River Side Sweaters Ltd. (10343)

Hasnabad super market, Keranigonj, Dhaka

31.MAY.2014

Identified Priority 1 Concerns

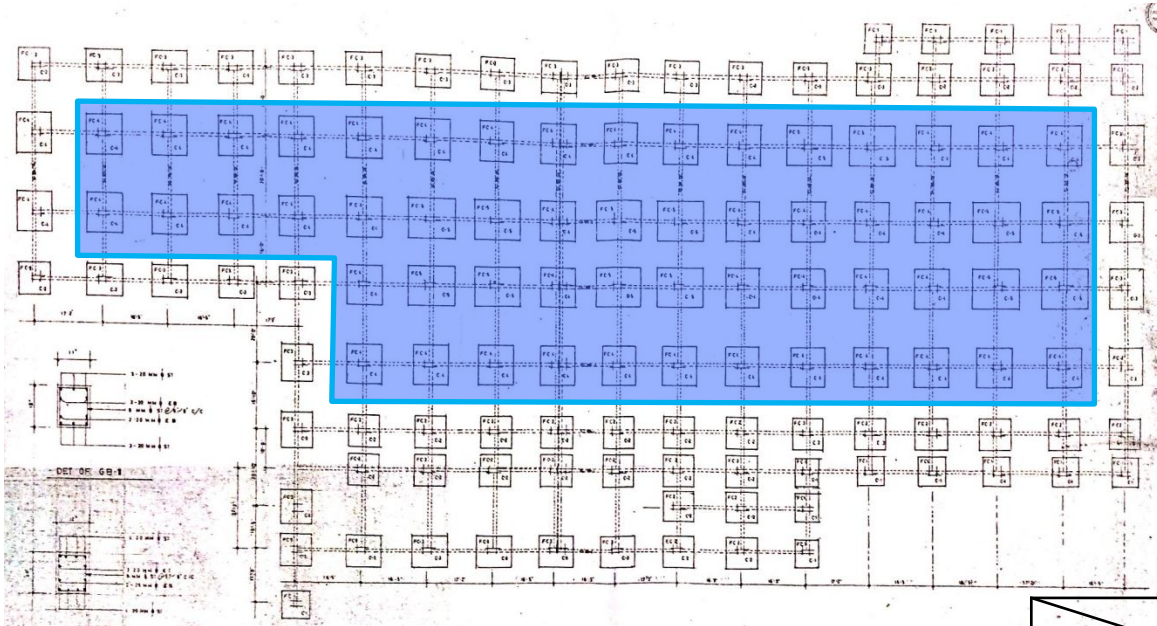
If the full construction of the 9 storeys is completed, the internal columns on basement floor shown in the picture below appear will be overstressed. The size of column is 21" x 14" at basement floor and will carry a full 9 storeys of building spanning 16' to 20' and 16'5" to 17'2" .

From the information above, for 9 storeys, the calculation check of typical columns show that they will be overstressed (FoS = **0.94**).

Remark: The size of column's rebar at basement floor is assumed to be similar to the size of column's rebar which left exposed on the top level.

In situ
Size	21" x 14"
Vertical rebar	12 – ϕ 16 mm (1.31%)
Aggregate	Brick

Item No.	Observation	Recommended Action Plan	Recommended Timeline
1	Priority 1 - In case of the full construction of the originally planned 9 storeys, internal columns on basement floor will be overstressed.	Factory Engineer to review design, loads and columns stresses in area identified above. Verify in-situ concrete stresses either by cores or existing cylinder strength data for 4 columns. A Detail Engineering Assessment of Factory to be commenced immediately.	Immediate – Now
2	Priority 1 - In case of the full construction of the originally planned 9 storeys, internal columns on basement floor will be overstressed.	Produce and actively manage a loading plan for all floor plates within the factory giving consideration to floor capacity and column capacity. Detail Engineering Assessment to be completed.	6-weeks
3	Priority 1 - In case of the full construction of the originally planned 9 storeys, internal columns on basement floor will be overstressed.	Continue to implement and maintain the loading plans. Use the results of the DEA to determine if the 9 storeys can be constructed or not.	6-months

2nd Priority 1 Concern

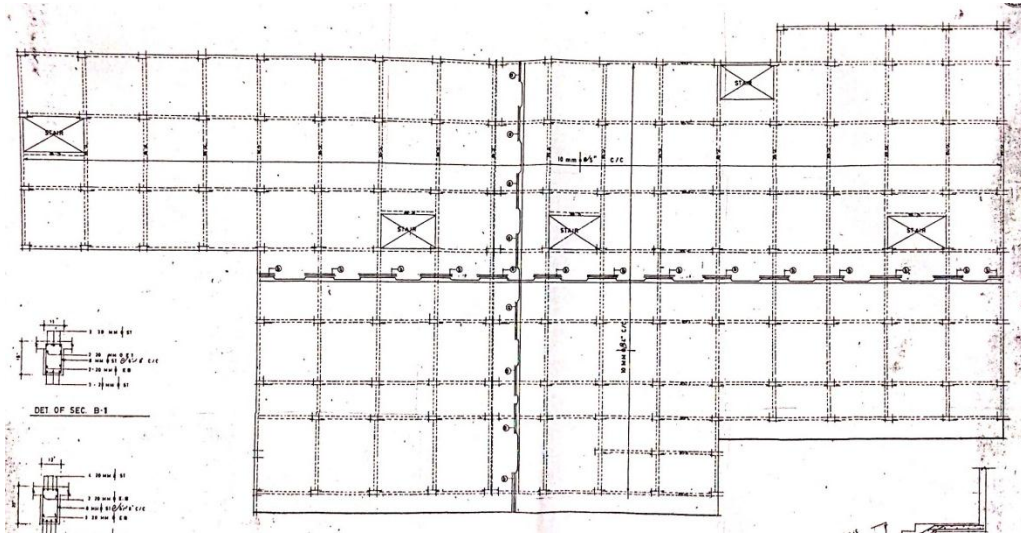
Advertising board was installed at roof level. Capacity and stability check of these items and related elements should be carried out.

4	Priority 1 - Stability and capacity check of the structural elements supporting advertising board at roof level.	Request that the Detail Engineering Assessment of the structural elements supporting the advertising boards to be carried out and in particular, stability and connections aspects should be investigated in detail.	Immediate – Now
5	Priority 1 - Stability and capacity check of the structural elements supporting advertising board at roof level.	Detail Engineering Assessment to be completed.	6-weeks
6	Priority 1 - Stability and capacity check of the structural elements supporting advertising board at roof level.	Complete any actions or recommendations from the DEA.	6-months
7	Priority 2 - Inconsistencies between the drawings and the actual as-built conditions.	Factory Engineer to survey the actual conditions and revise the drawings. Any results of the DEA which affect the structure should be taken on board.	6-weeks
